ADDENDUM
NO. 3

July 31, 2020

Additions & Renovations to Lawrence North High School
7802 Hague Road
Indianapolis, IN 46256

PREPARED BY SCHMIDT ASSOCIATES FOR:
LAWRENCE NORTH HIGH SCHOOL RENOVATION
LAWRENCE TOWNSHIP, M.S.D. OF

E. **Drawing Number PP101**

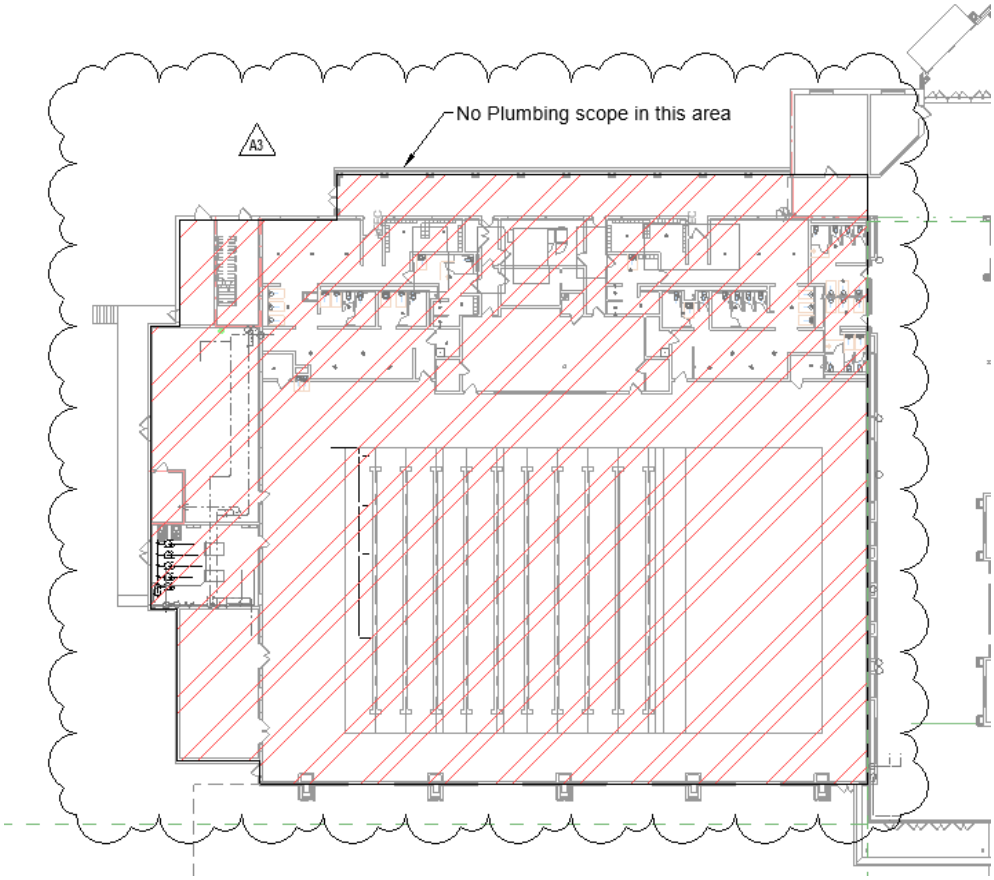
Plumbing scope clarification.

F. **Drawing Number PP1E1**

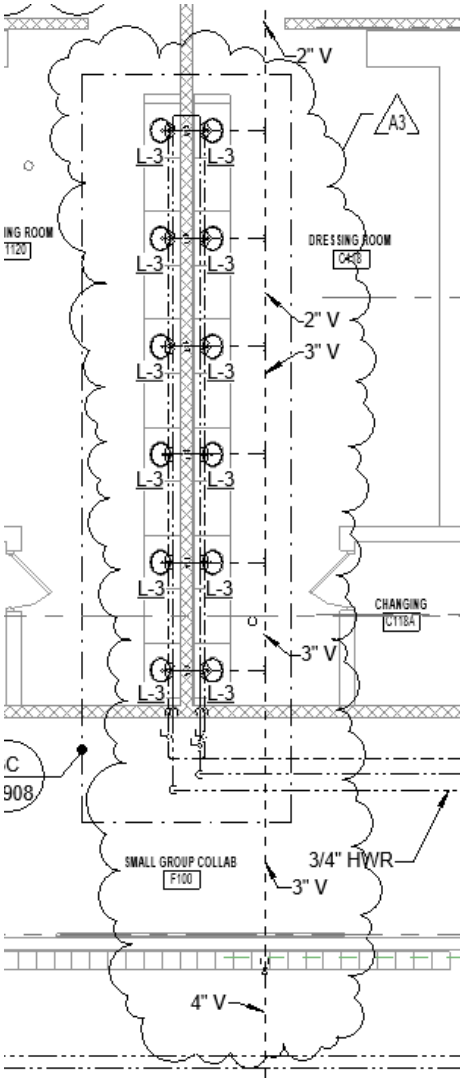
Routing and connections of vent piping changed.

G. **Drawing Number PP1H1**

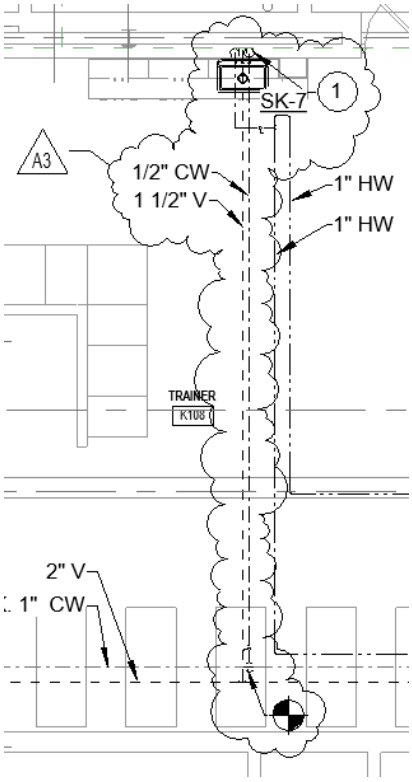
Added SK-7 and associated piping.

H. **Drawing Number PP1H1**

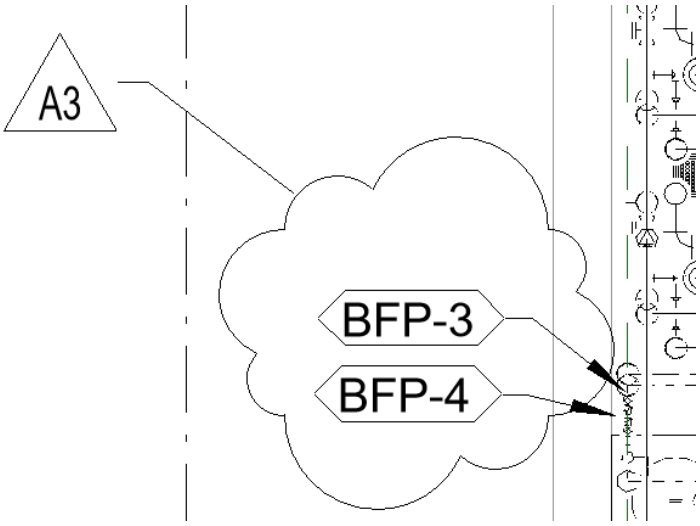
Added tags to backflow preventers.

I. **Drawing Number FPD101**

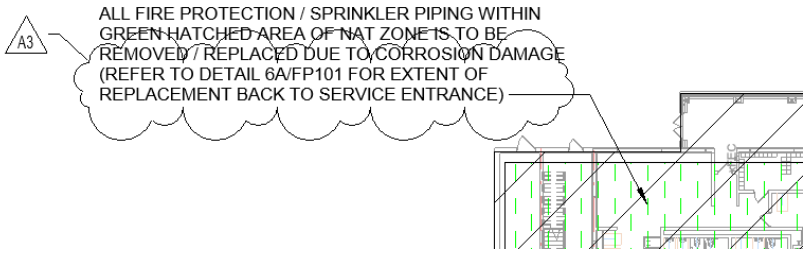
Drawing scope note was updated.

J. **Drawing Number FPD101**

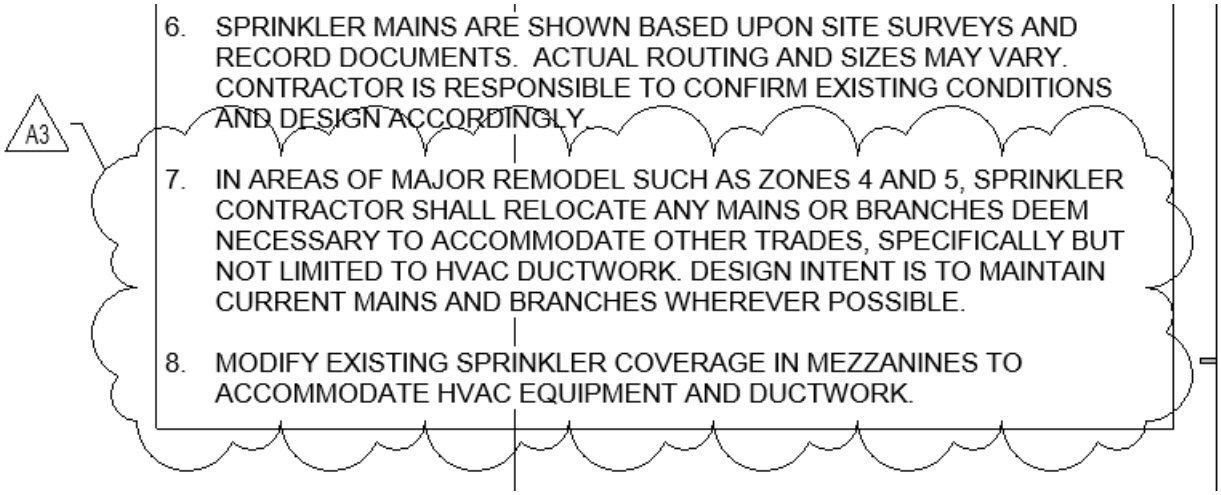
Fire Protection Notes 7 and 8 were updated.

K. **Drawing Number FP101**

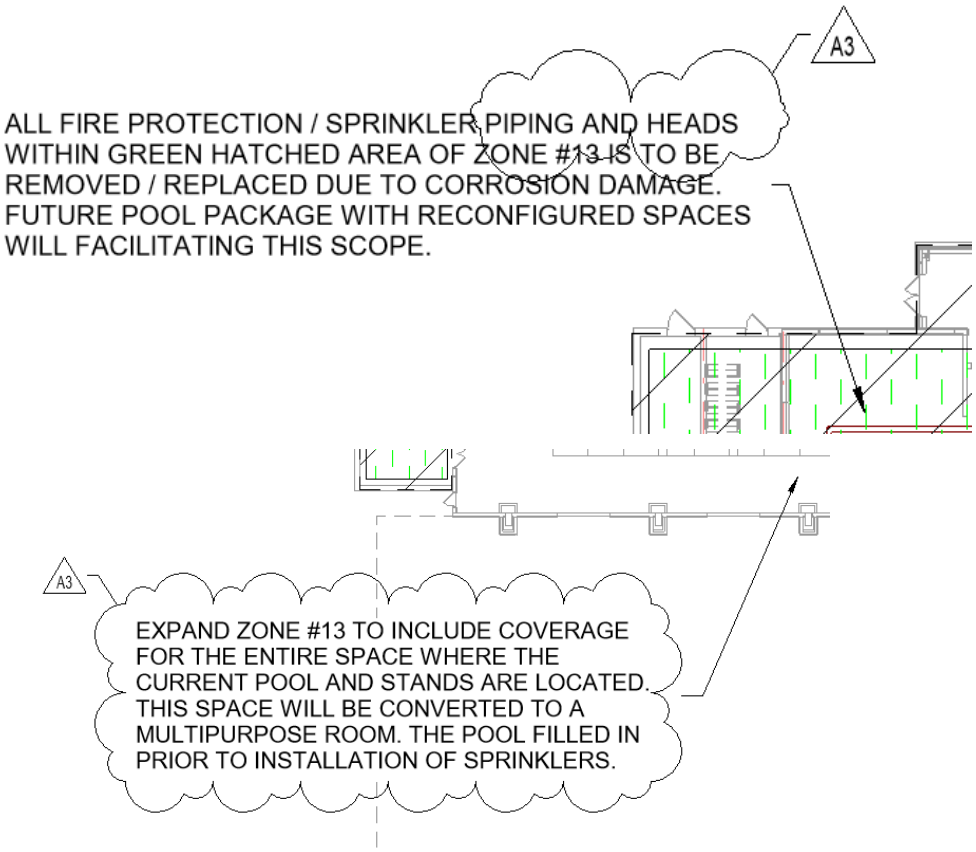
Drawing scope notes were updated.

L. **Drawing Number FP101**

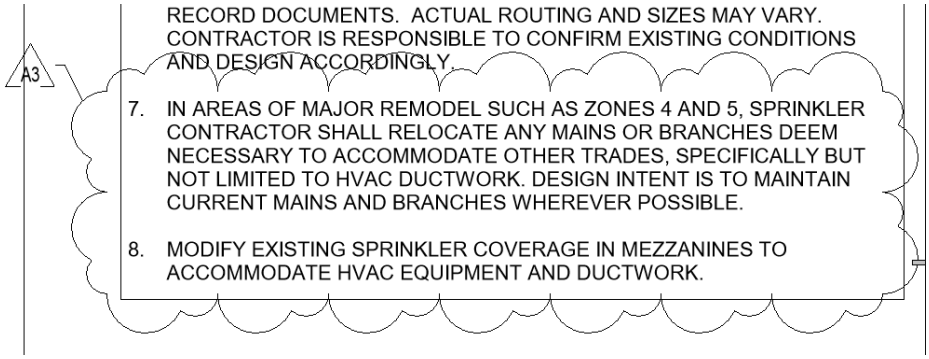
Fire Protection Notes 7 and 8 were updated.

M. **Drawing Number FP101**

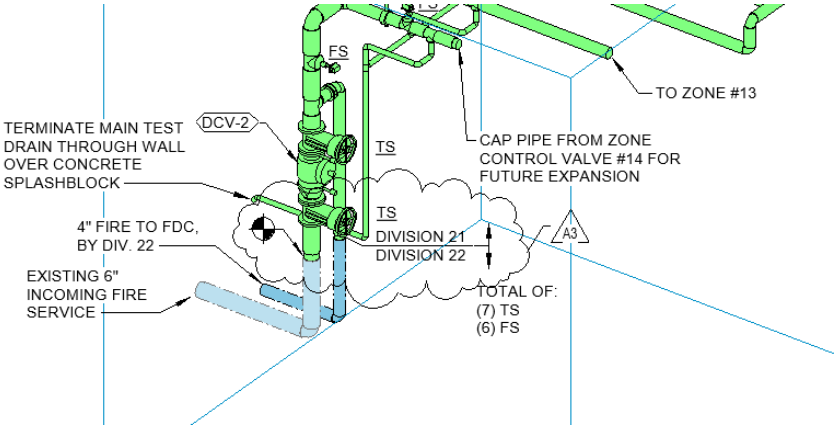
Added scope clarification to detail 6A.

N. **Drawing Number P-903**

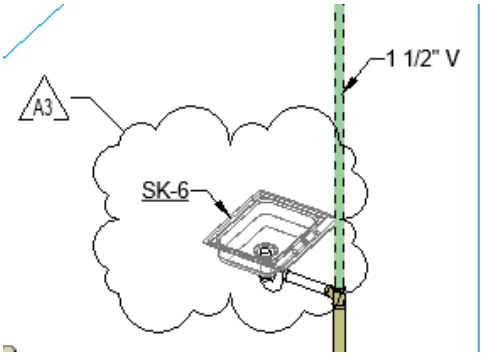
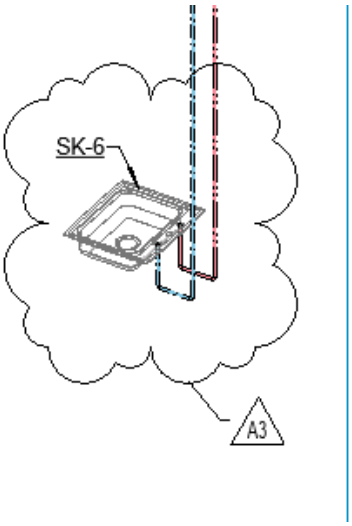
SK-6 was not showing up in the ISO.

O. **Drawing Number P-908**

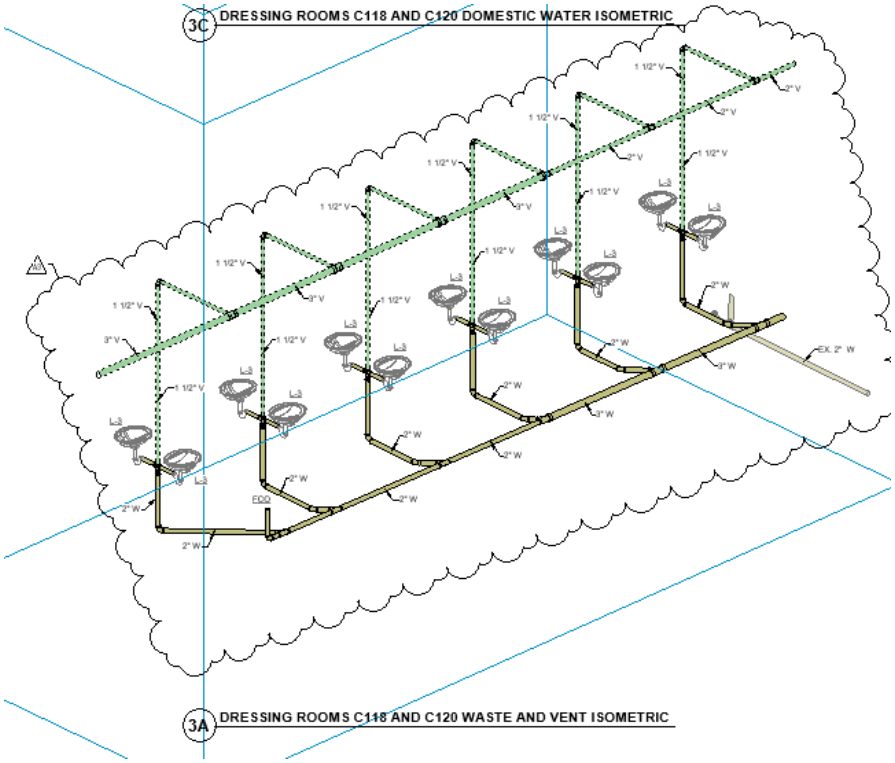
Sanitary waste and vent isometric was updated to match floor plan.

P. **Drawing Number P-909**

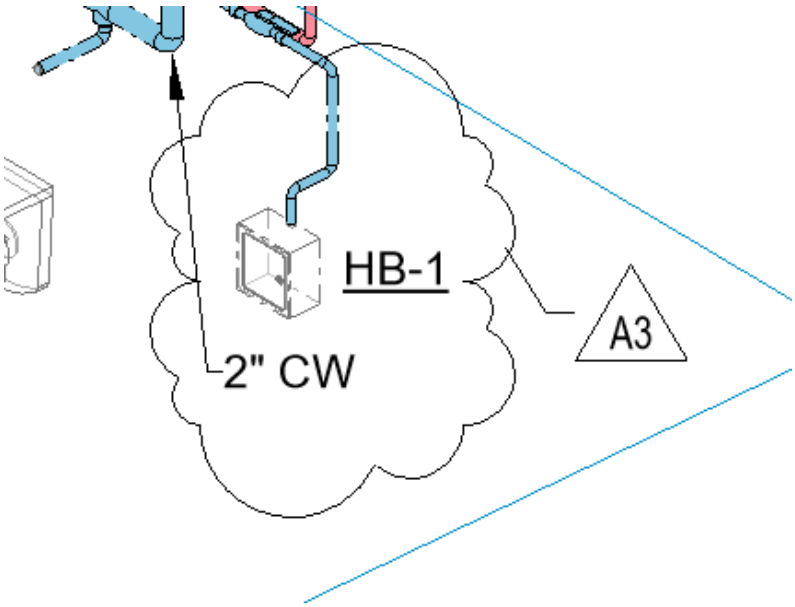
Fixture tag was added to HB-1

Q. **Drawing Number P-910**

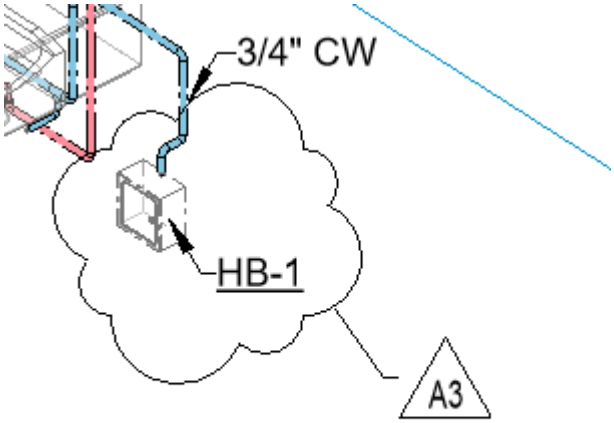
Fixture tag was added to HB-1

R. **Drawing Number P-910**

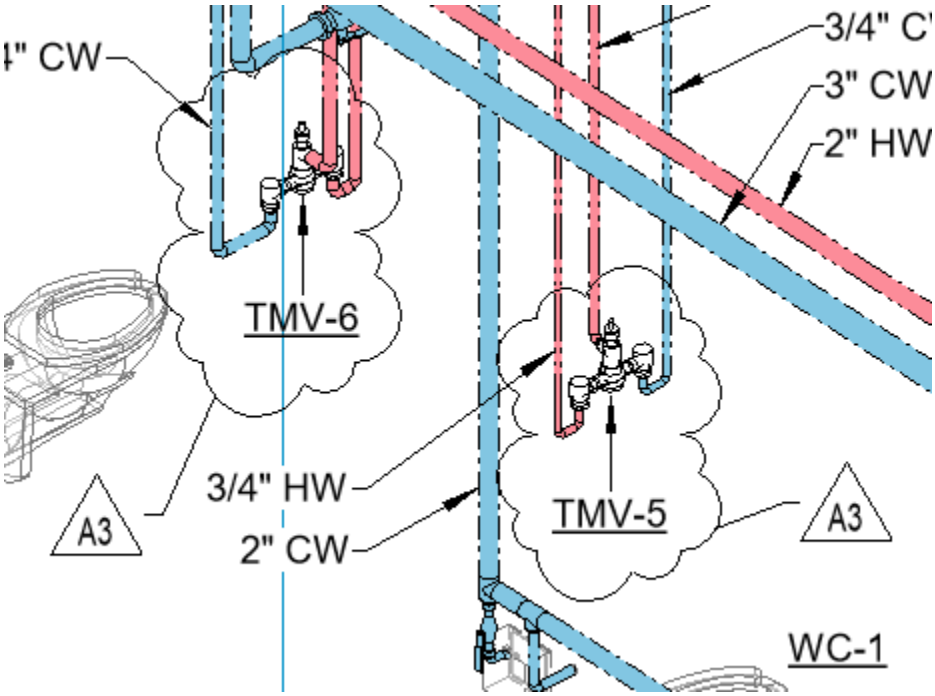
TMV equipment tag was updated.

A. **Drawing Number EP1B1.**

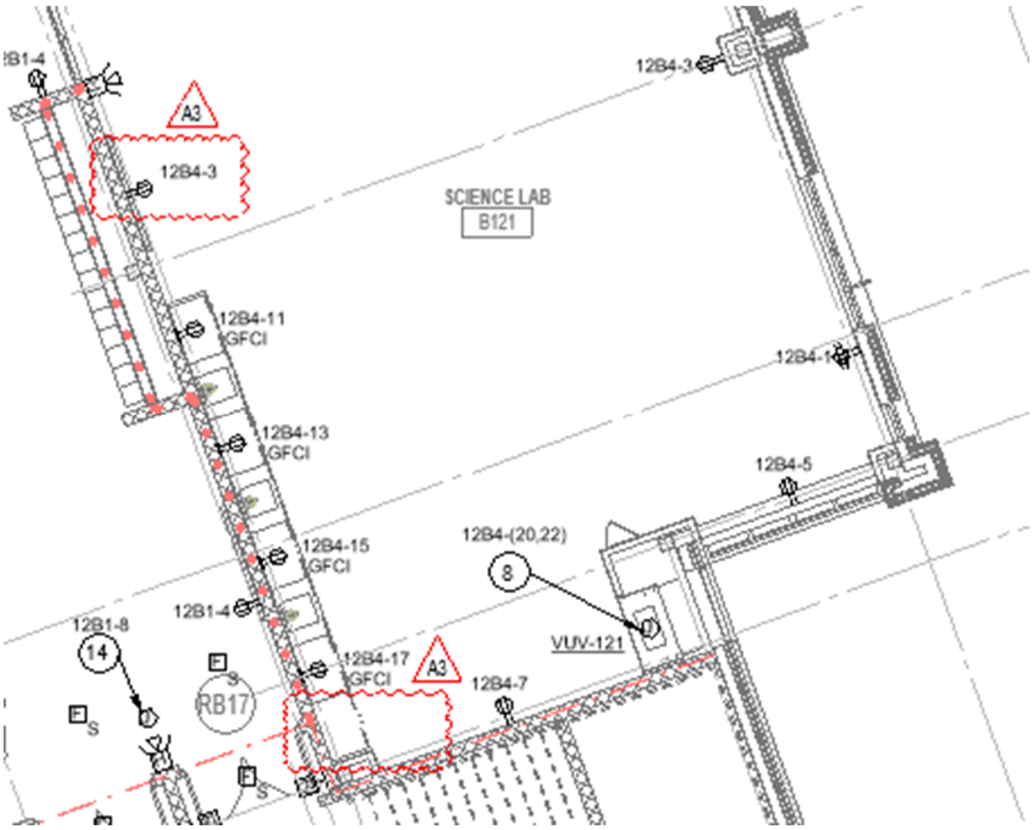
1. In B121, change power receptacles as shown below:

B. **Drawing Number EP1D1.**

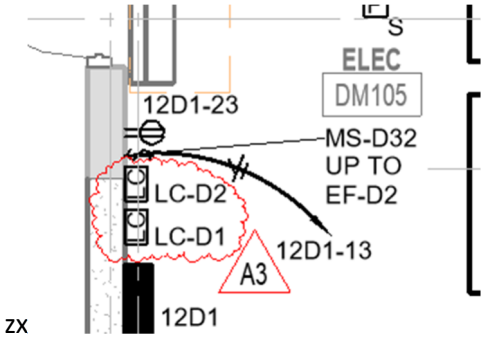
1. In DM105, add lighting contactor labels as shown below:

J. **Drawing Number EP1J2.**

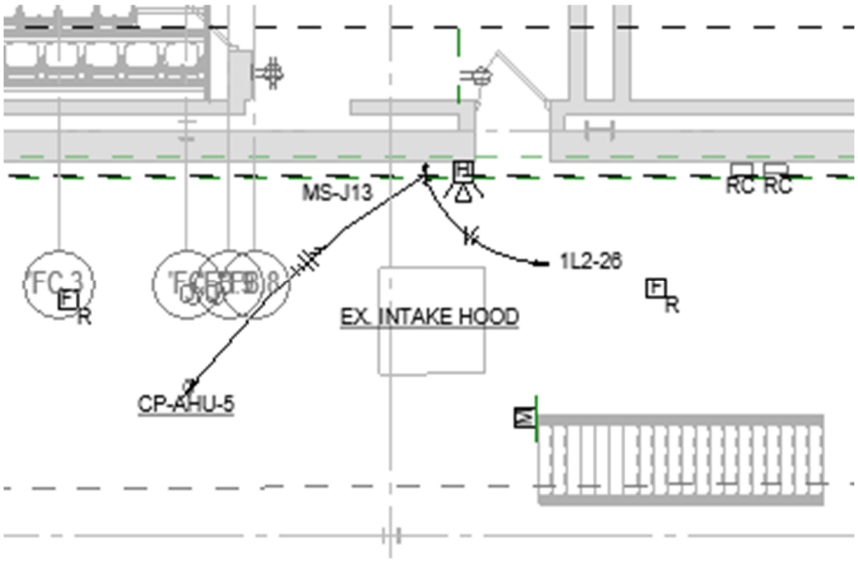
1. In Unit J second floor mezzanine, circuit CP-AHU-5 as shown below. Provide 20A circuit breaker.

K. **Drawing Number EP1B3.**

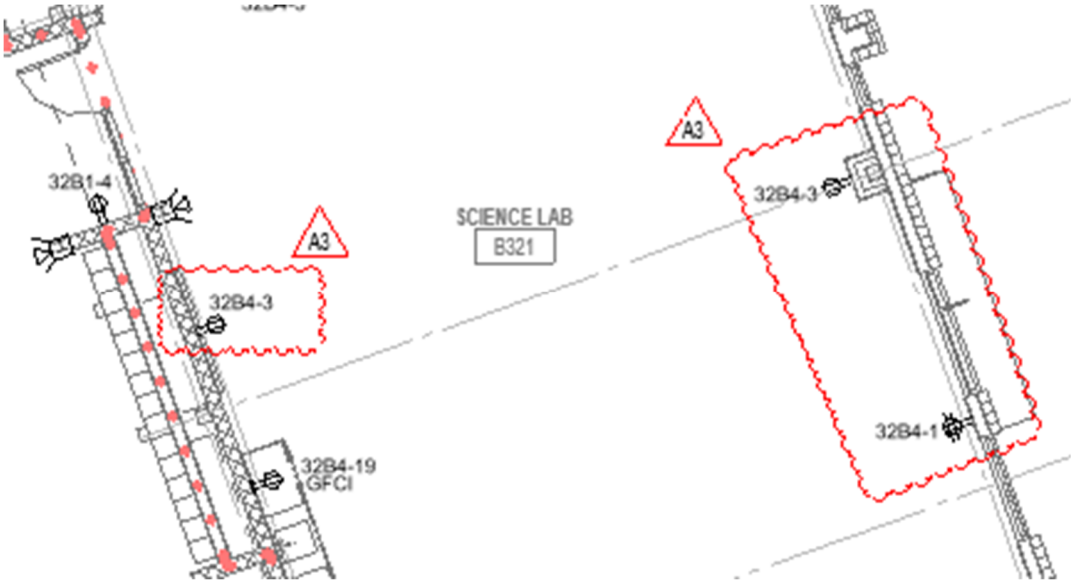
1. In B321, change power receptacles as shown below:

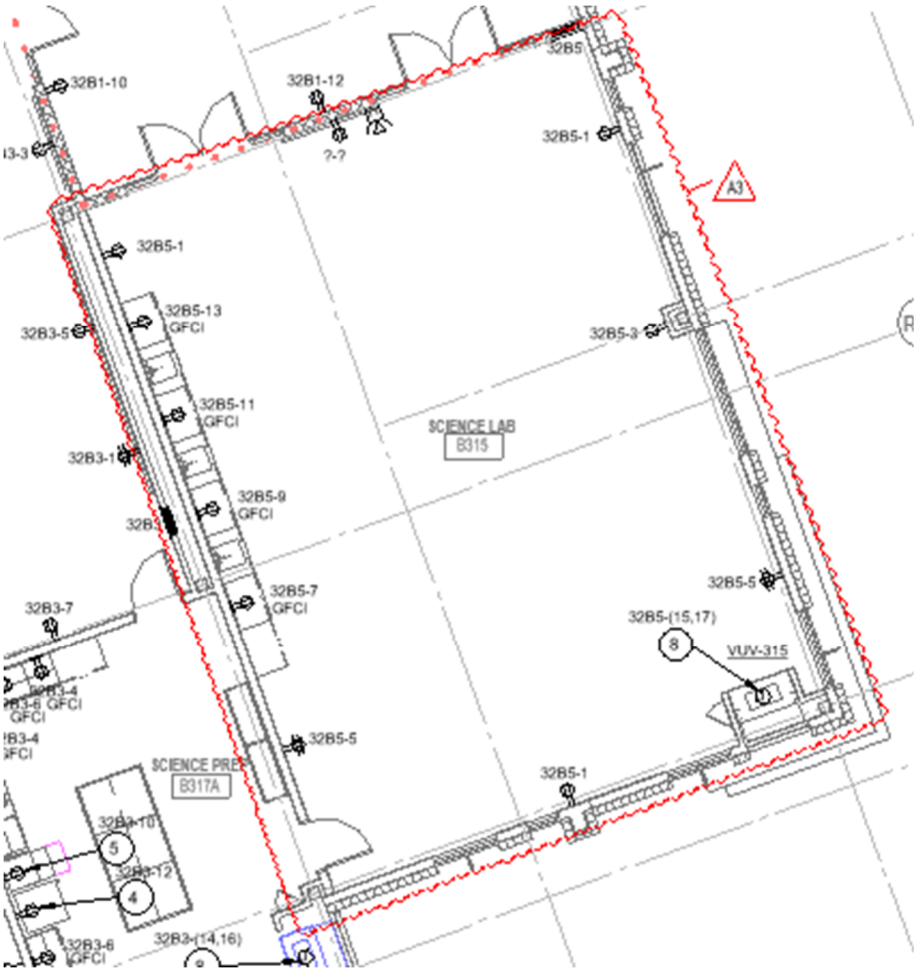
2. In B315, change power receptacle circuits as shown below:

M. **Drawing Number ER101.**

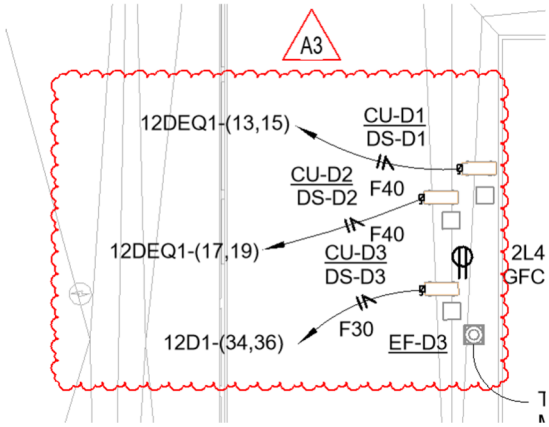
1. At CU-D1 and CU-D2, change circuits as shown below. Provide 40A circuit breakers.

2. At CU-D3, change circuit as shown below. Provide 30A circuit breaker.

N. **Drawing Number ER102.**

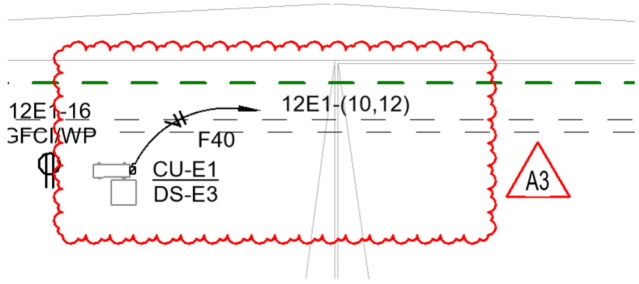
1. At CU-E1, change circuit as shown below. Provide 40A circuit breaker.

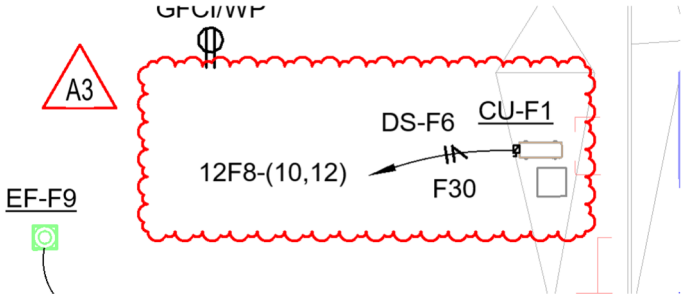
2. At CU-F1, change circuit as shown below. Provide 30A circuit breaker.

O. **Drawing Number ER103.**

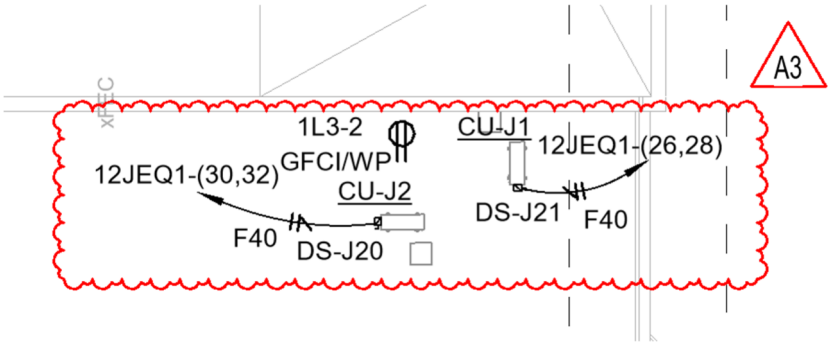
1. At CU-J1 and CU-J2, change circuits as shown below. Provide 40A circuit breakers.

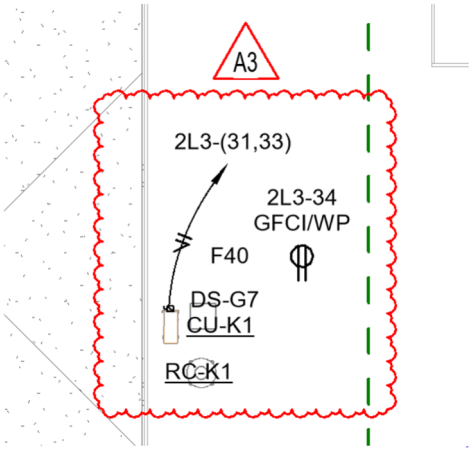
2. At CU-K1, change circuit as shown below. Provide 40A circuit breaker.

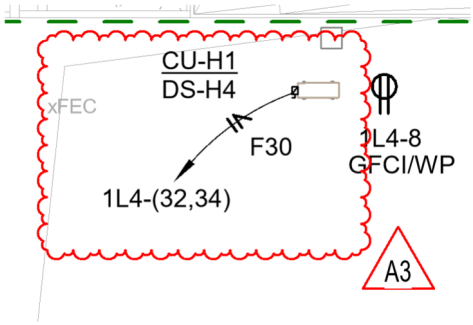
3. At CU-H1, change circuit as shown below. Provide 30A circuit breaker.
